CITY OF ALBUQUERQUE

RE: **Volcano Cliffs Subdivision Lot 1, Block 8, Unit 18**
6512 Papagayo Rd. NW
Grading and Drainage Plan
Engineers Stamp Date 1/30/17 (D10D003O1)

Based upon the information provided in your submittal received 1/17/17, the above referenced Grading and Drainage plan dated 1/17/17 cannot be approved for Grading Permit until the following comments are addressed:

GRADING & DRAINAGE PLAN
65112 Papagayo Road, NW
LOT 1, BLOCK 8, UNIT 18 VCS

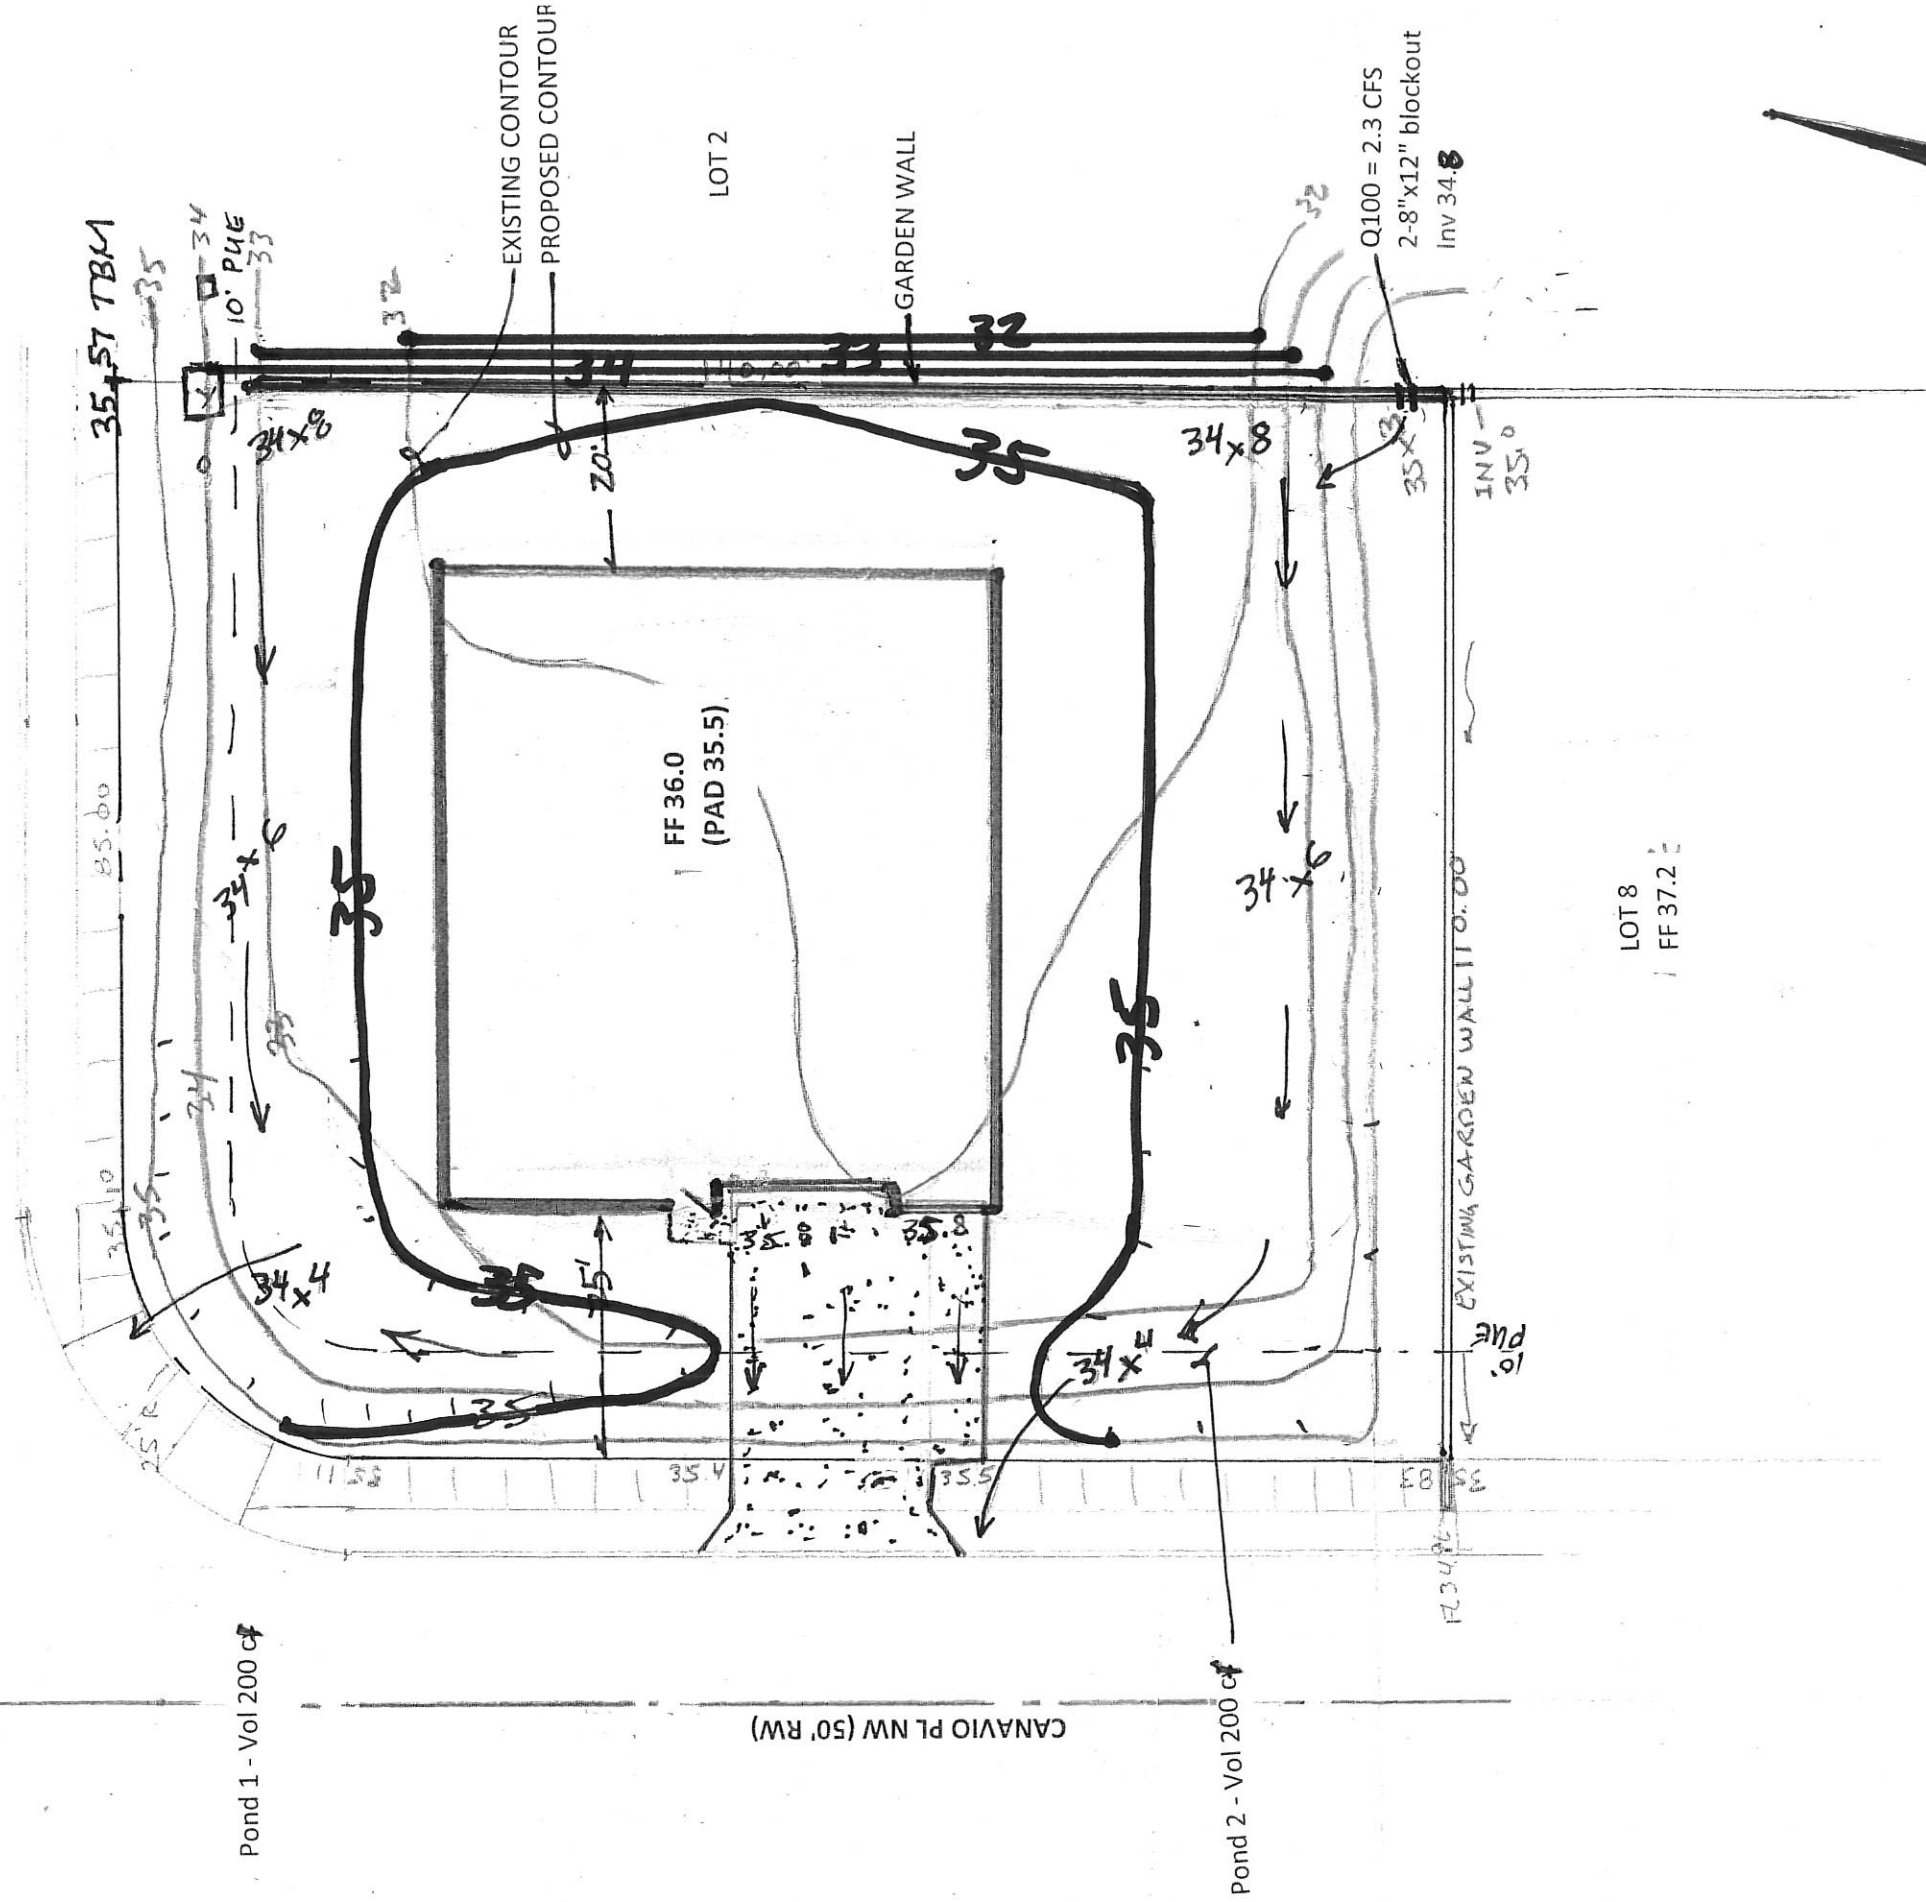
- Provide a note stating that future garden walls require a separate permit and this plan should be used for their placement.
- Also state that future garden walls require an opening 3" above grade in the SW corner.
- Provide a statement that a pad certification is required before a building permit is given.

- Note:
1. Future garden walls require a separate permit and this plan should be used for their placement.
 2. Future garden walls require an opening 3" above grade in the SW corner.
 3. A pad certification is required before a building permit is given.
